[NOTE: Changes in red were recommended by the Environmental Planning Commission at its hearing February 13, 2014. Numbers in brackets indicate the associated Condition of Approval from the Notice of Decision. Changes in blue are subsequent changes recommended by staff.]

WEST SIDE STRATEGIC PLAN AMENDMENT

The amendment to the West Side Strategic Plan that follows shall be inserted after page 154 of the West Side Strategic Plan, at what is currently the end of Section 3 Specific Westside Communities, to continue after Policy 3.94.

Exhibit 2, Relationship of the Volcano Mesa Area to the Volcanoes and Larger West Mesa Community

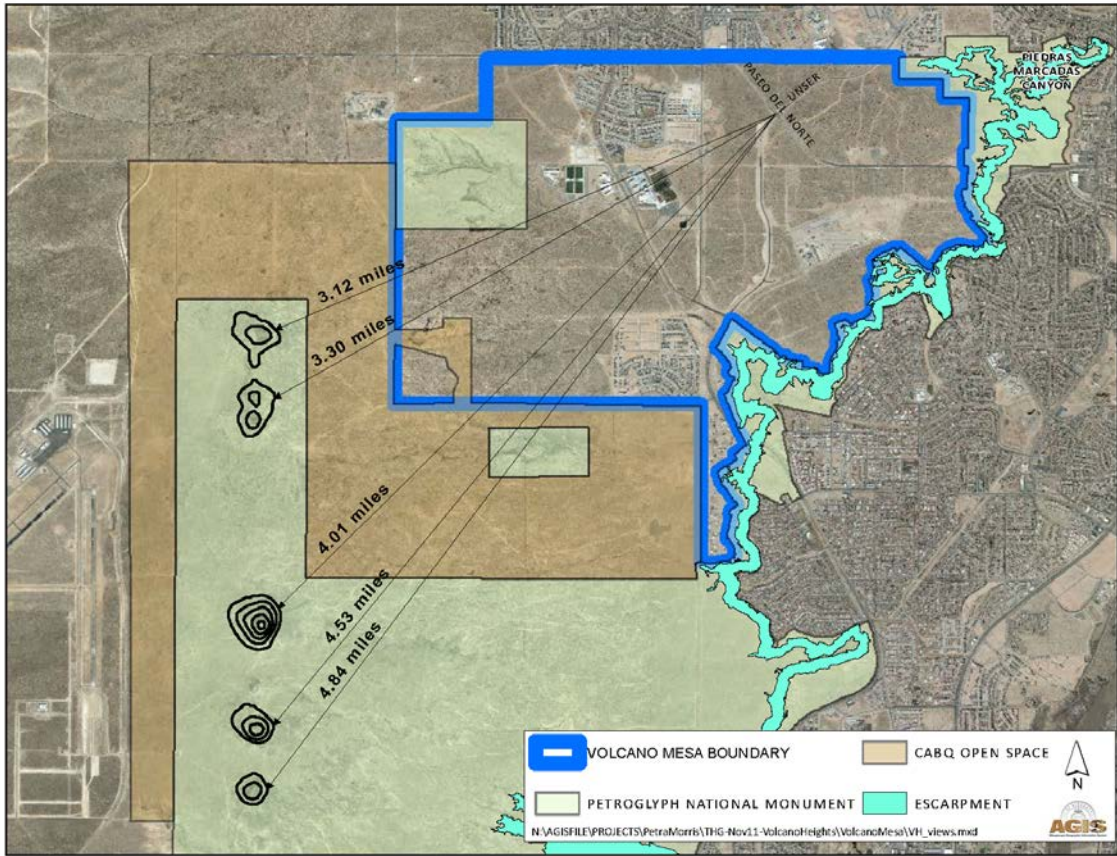
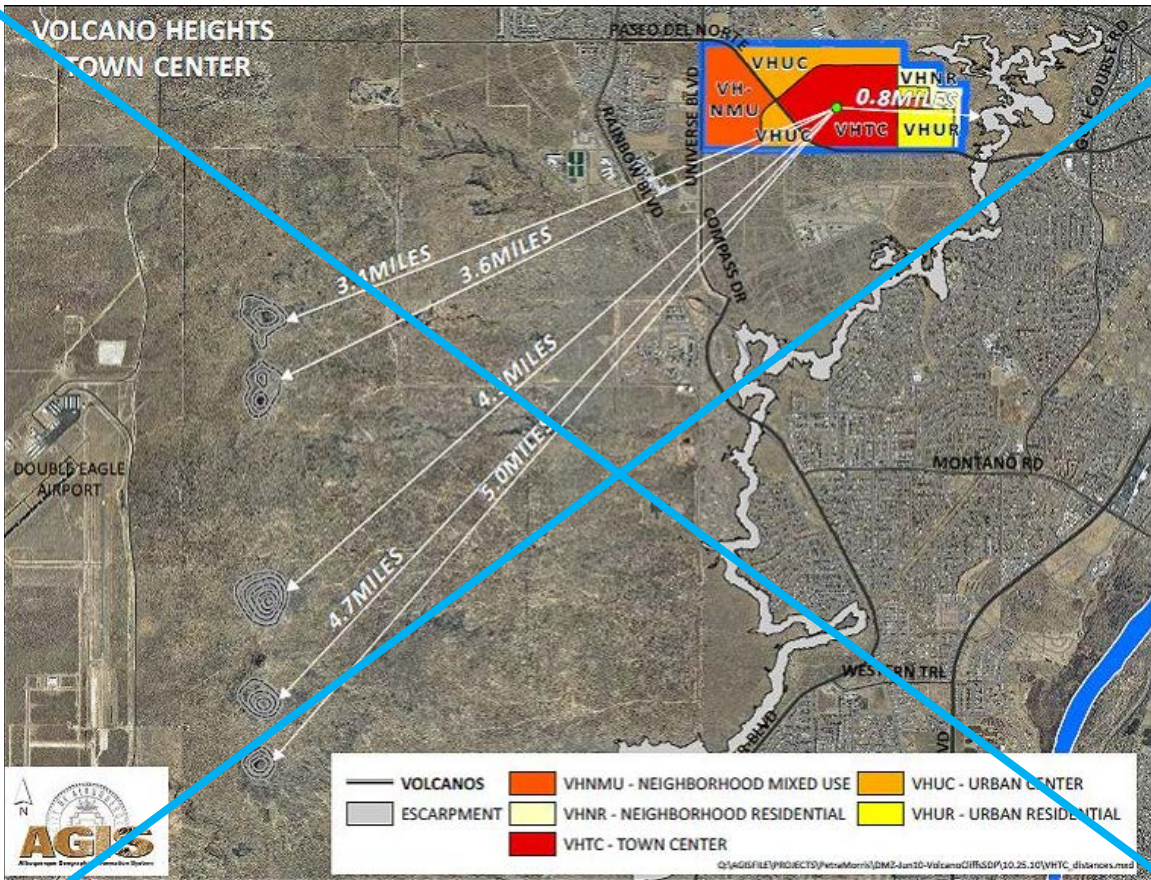
[Updated]

Exhibit 10, Road Network Map

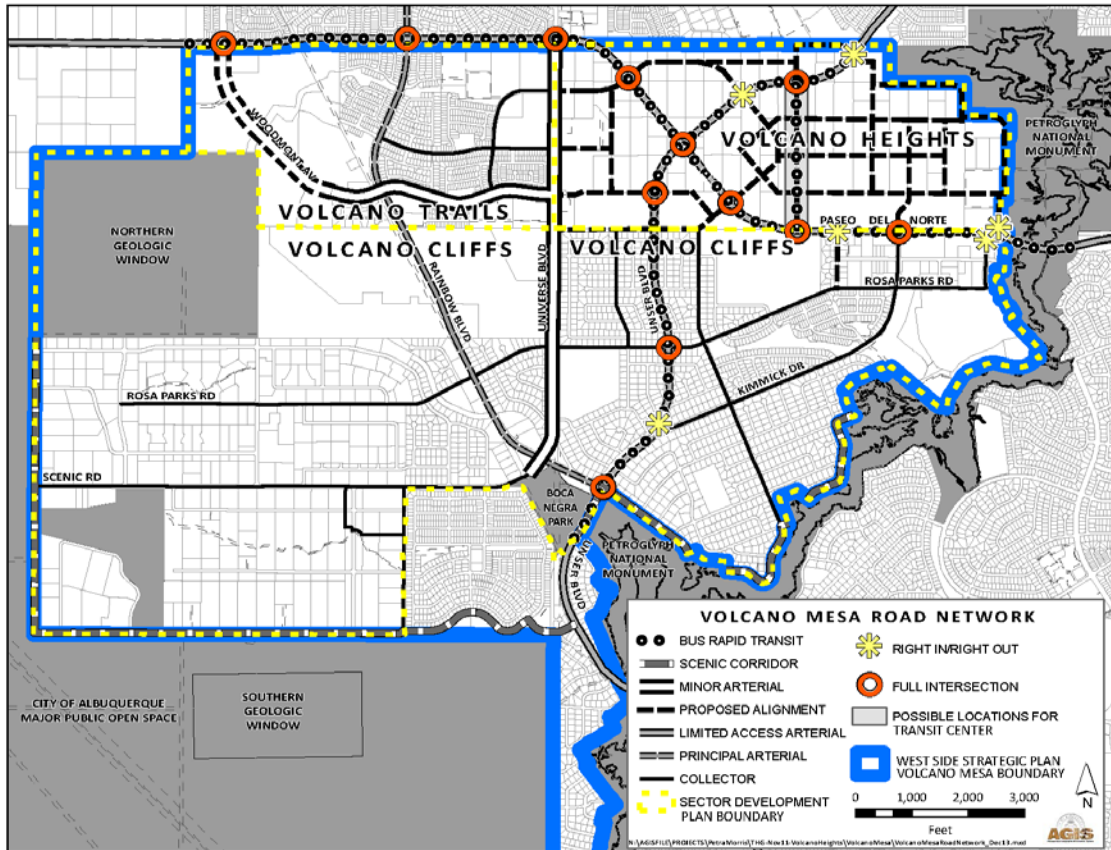
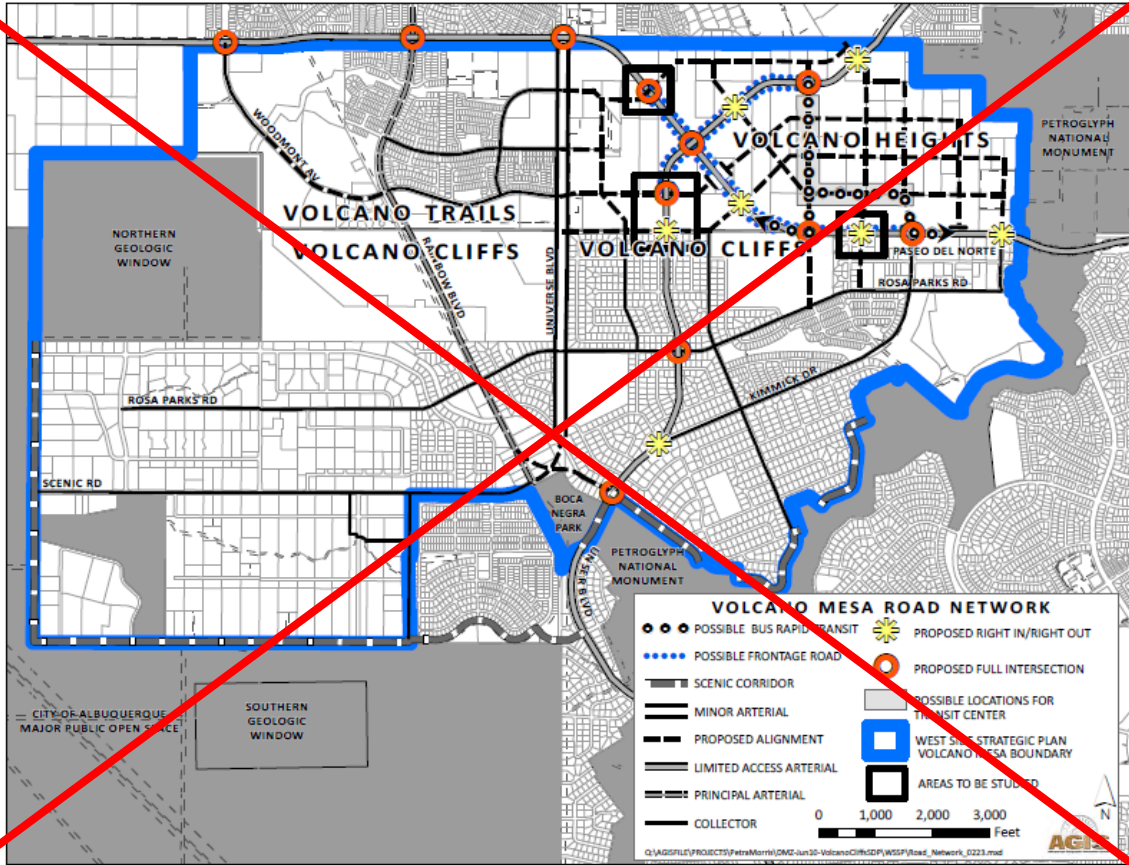
Policy 3.110 Access points on Paseo del Norte and Unser Boulevard should be limited to those shown in Exhibit 10, Road Network Map. When constructed, intersections should be carefully designed with multimodal accommodations to ensure safe access for pedestrians and cyclists to enhance the connectivity and walkability of this Major Activity Center, balanced with minimizing delay for regional through traffic.

~~The access points to Paseo Del Norte and Unser, shown in Exhibit 10, Road Network Map should be adopted.~~

~~MRCOG defines Unser and Paseo Del Norte as “limited access roadways” designed to carry high volumes of regional traffic. To maintain travel speeds, intersection spacing is restricted. However, a key component of the Roadway plan (See Exhibit 10) is the proposed access locations along Unser Blvd. and Paseo Del Norte within the Volcano Mesa area. While both roads are currently designated Limited Access Arterials, whose main function is to move traffic quickly and efficiently, these arterials must now provide access to and from adjacent neighborhoods as well as the Volcano Heights sub area in order to support the level of employment, commercial, and residential uses envisioned for the Volcano Heights Major Activity Center. The proposed access points, both full and right-in/ right-out, provide essential connections into and within the Volcano Mesa area and form the basis of the area’s internal network. In addition, the proposed access points facilitate access to transit and the proposed Transit Center located in the Volcano Heights sub area. Proposed access points are shown on the Roadway plan, these access locations are generally located to provide optimal connections to, from, and within the Volcano Mesa area and the Volcano Cliffs sub area. [4]~~

[5, 6, 7]
